MODEL BENTLEY MARK VI

MODIFICATIONIGNITION COIL INPUT SUPPRESSOR

M O D I F I C A T I O N .HORN PUSH BUTTON ASSEMBLY.

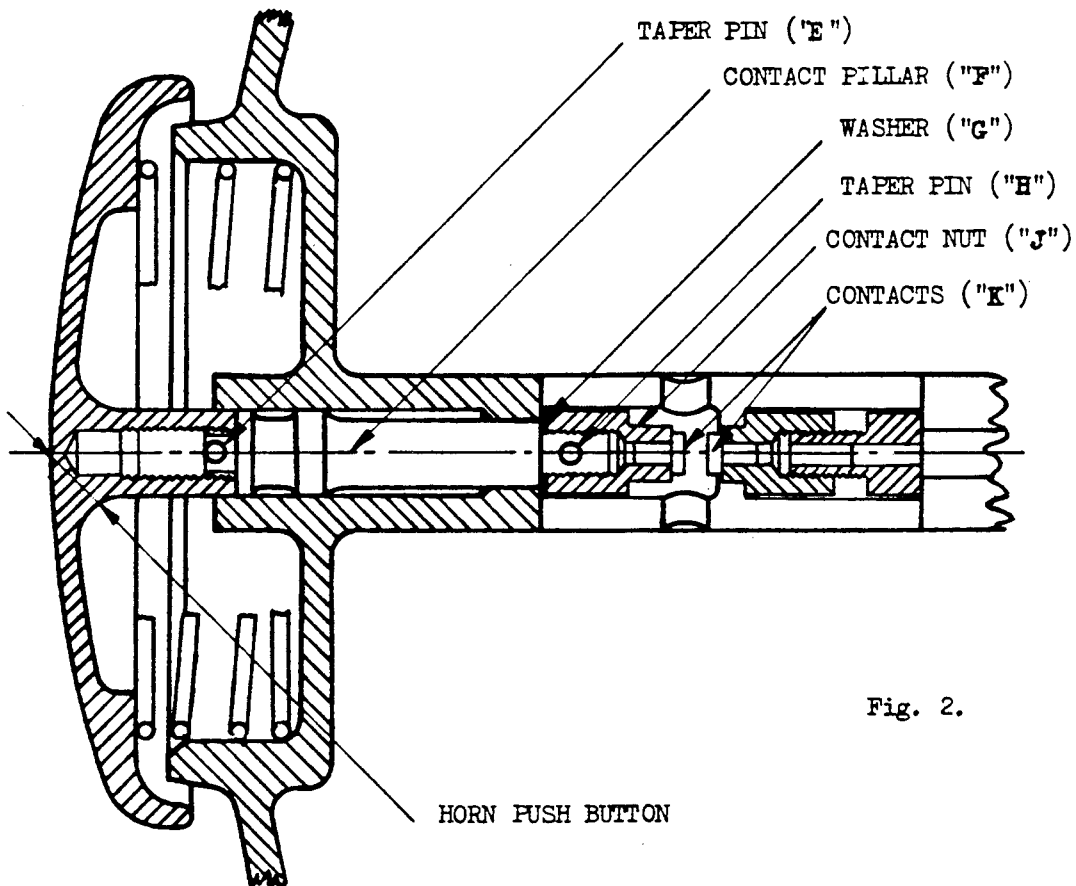
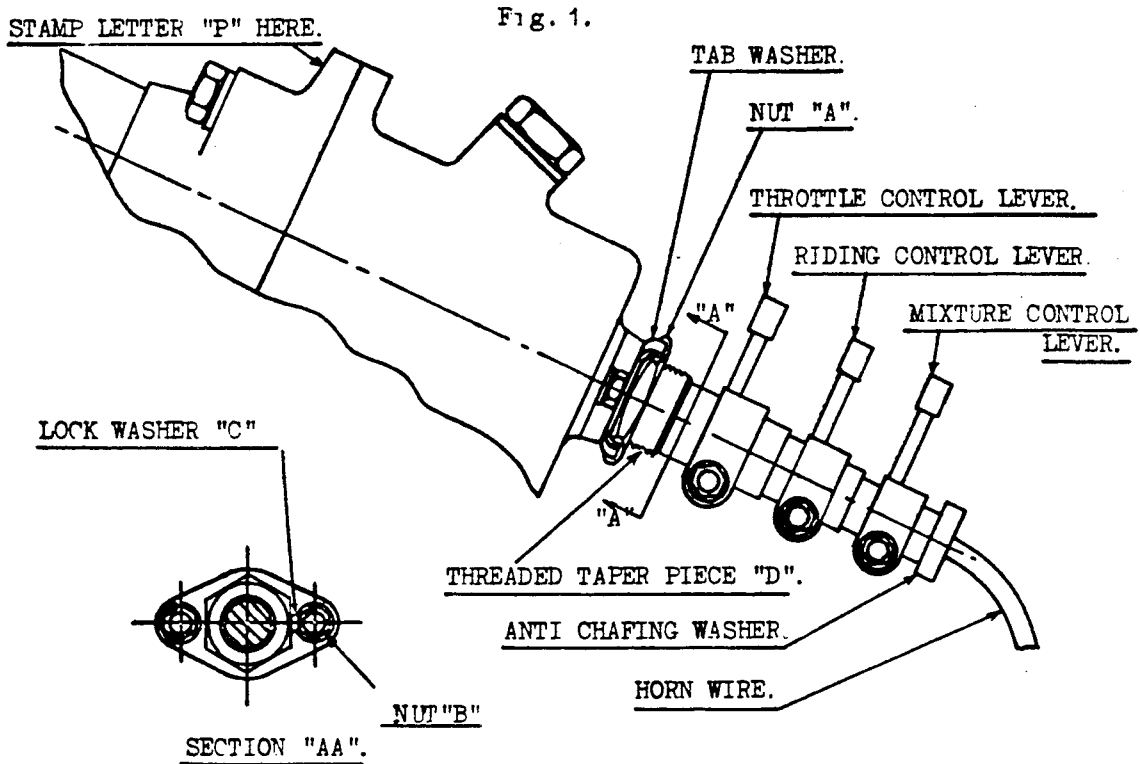
A modification is introduced to the horn push button assembly to give additional strength where the contact pillar is screwed into the horn push. The alteration consists of the substitution of the taper pin locking by sweating.

From the horn push button unit tap out the taper pin 'H' and remove the contact nut 'J' and the brass washer 'G'. The push button and its contact pillar 'F' is now free to be removed from its cover.

Tap out the taper pin 'E' from the contact pillar and unscrew the pillar from the button. This contact pillar, with holes drilled through both its threaded portions, and the taper pin 'E' can be discarded.

A new contact pillar, with its top threaded portion tinned with solder is screwed and sweated into the push button.

A distance of .040" between the contacts is desirable, and this is obtained as follows:-

The amount of this travel is regulated by the thickness of the brass washer 'G'. If the horn sounds before the button nips the feelers, the brass washer requires reducing in thickness, but if a greater travel than .040" is obtained before the horn sounds, then a thicker washer is required.

When the correct amount of travel is obtained, the contact pillar is drilled through the existing holes of the contact nut 'J' and the taper pin 'H' fitted. The unit may now be finally refitted in the steering wheel hub.

RUN OF WIRING, POSITION OF CLIP, RUBBER SLEEVES AND SUPPRESSORS.CARS ON WHICH MODIFICATION ACTION IS NOT NECESSARY:

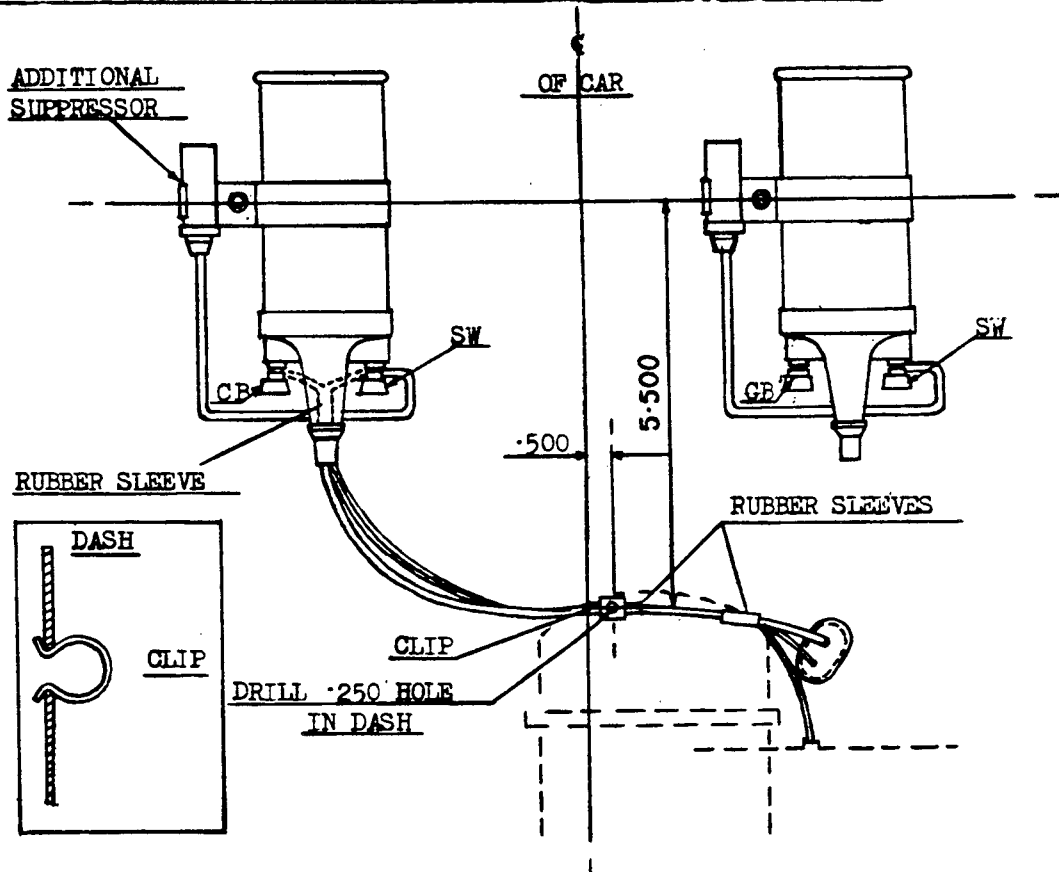
A modification is introduced to obviate the necessity for moving the existing ignition coil suppressor condenser when the spare ignition coil is being used. In conjunction with this modification, a clip is fitted to the dash to group the coil wires together and rubber sleeves to the wires to prevent chafing.

This is to be fitted to the off-side fixing bolt of the off-side ignition coil bracket and the suppressor lead connected to the INPUT (S.W.) terminal of the coil.

A hole .250" diameter should be drilled through the dash at the point indicated in the attached drawing. This position is immediately behind and on a level with the top of the rocker cover which can be removed to facilitate drilling the hole. The rocker gear should be covered to prevent the entry of swarf during the drilling operation. The drill should not penetrate the dash more than 5/16" as this will cause damage to the insulation situated immediately at the rear of the dash.

These should be positioned on the wires as shown in the attached sketch. The wires should be connected to the off-side coil, the radio switched on and the engine run to check the suppressor and the ignition coil for correct functioning. The wires can be left connected in this position, the near-side coil becoming the spare.

FIG. 2. CONVERSION ASSEMBLY FITTED.

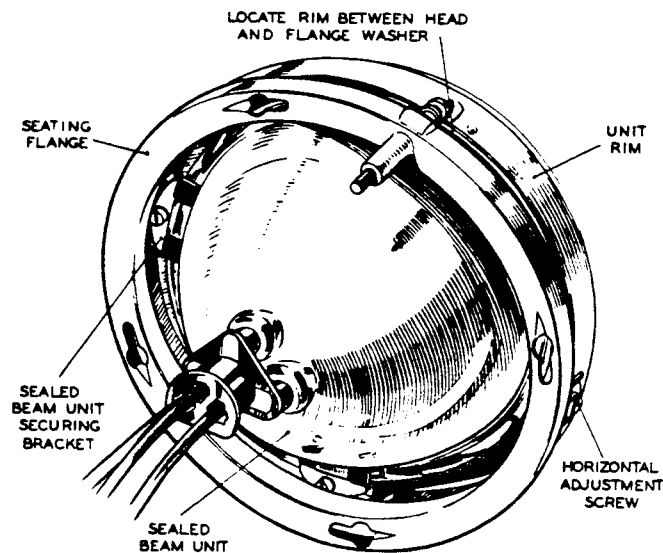
Connection to the Sealed Beam unit is made by means of a three point adaptor plug. To make the connections, proceed as follows:-

- (i) Bare approximately $\frac{3}{8}$ " of the cables.
- (ii) Remove the adaptor from the Sealed Beam unit.
NOTE: It will be observed that the rear of the adaptor is marked "Ground", "Pass" and "Drive".
- (iii) Remove the three spring contacts from the adaptor.
- (iv) Solder the core of the black cable to one of the spring contacts and fit the contact in the recess of the adaptor marked "Ground".

FIG. 1.

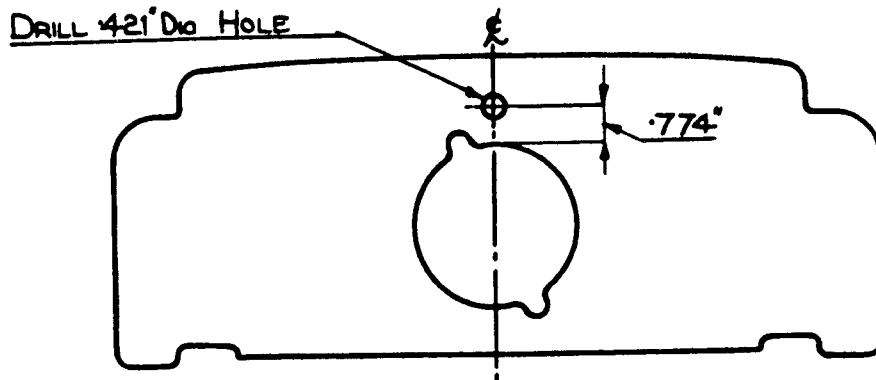
4. Fit the switch supplied into the vacant hole in the top of the instrument panel above the switch box. If this hole does not already exist, drill as shown in Fig.1.

FIG. 2.

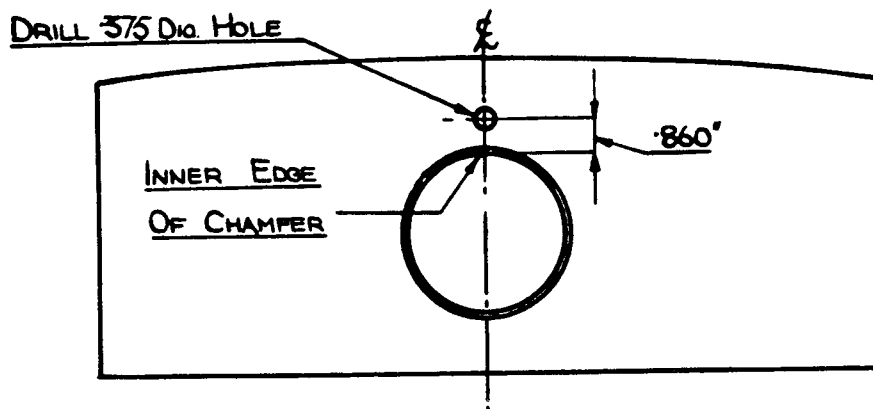
5. Drill the wooden fascia panel as shown in Fig. 2.

FIG. 1.

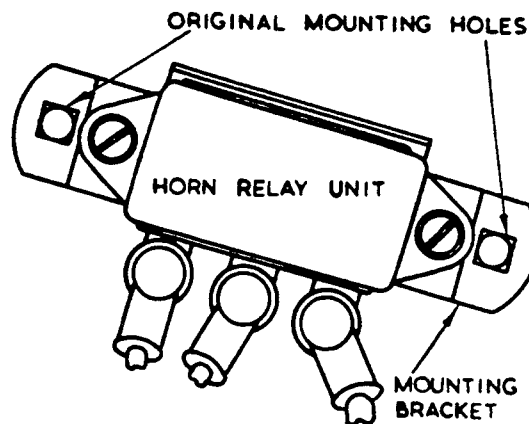
Retailers are advised that the Lucas C585K horn relay unit (Part No. RD-3084) as at present fitted, has been superseded by the Lucas SB-40 type unit (Part No. RD-6351), and that this is now the only replacement available.

Fig. 1 illustrates the general arrangement of the new assembly when installed on a car.

- 1) Remove the cover and disconnect the cable assemblies from the existing horn relay unit. Remove the relay unit from the valance plate.
- 2) Fit the new mounting bracket (RD-6352) to the valance plate, using the two shorter 2BA bolts supplied. Mount the replacement relay unit on to the bracket using the two 2BA cheesehead screws supplied.
- 3) Reconnect the cable assemblies to their respective terminals on the new relay unit.

FIG. 2. DRH.8859 CONDENSER
(Current Replacement)

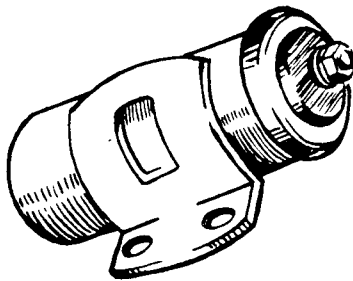
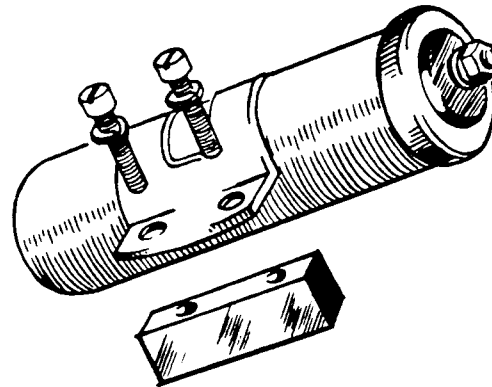
The ignition condenser (Delco-Remy Type DRH.1386, Part No. RD.6258) hitherto fitted on all chassis in production has been superseded by the improved DRH.8859 type unit, which is now the only replacement available.

Although the new type condenser is interchangeable and is fitted on the distributor in a similar manner to the original unit, it will be observed from the above illustrations that a distance piece is also included. This is due to the difference in the relative angular setting of the mounting bracket.

Fig.1. DR 3. Type windscreen wiper motor.

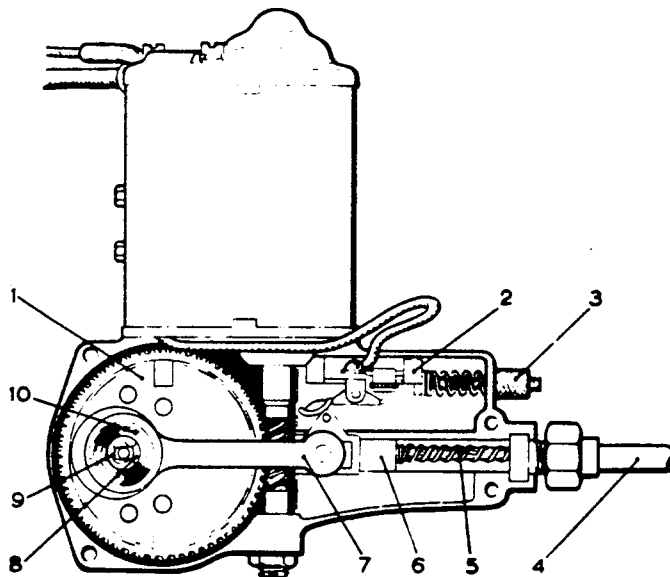
A new wiper motor (DR.3. type) is now being fitted to current production cars and by reason of its greater torque output and modified design, is an improvement on the DR.1. type motor which was fitted previously.

Attach the triangular bracket to the mounting plate, supplied with the new wiper motor, by means of two 2 BA screws.
